Re: Response to Transportation Peer Review Comments
Proposed 40B Residential Development – The Birches
Long Ridge Road – Carlisle, Massachusetts

Response to November 3, 2014 Letter from Nitsch Engineering

Photo 1: Hanover Road Bus Stop

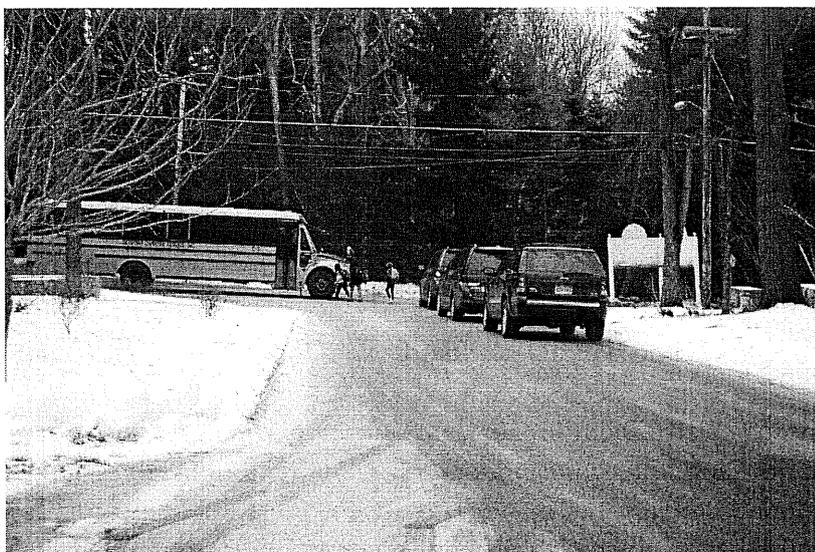
Comment 1: It is our understanding that the ZBA is concerned with vehicles temporarily parking at The Birches entrance should a bus stop be designated on Long Ridge Road.

Response: As is common in many communities, including Carlisle, parents of elementary school children regularly drive to their child's school bus stop. If a bus stop at the Long Ridge Road/Site Roadway intersection is approved by the Carlisle Public Schools, we expect that several vehicles may be temporarily parked on the internal roadway as is common throughout the Town (see photo of Hanover Road, a 20-foot wide residential roadway).
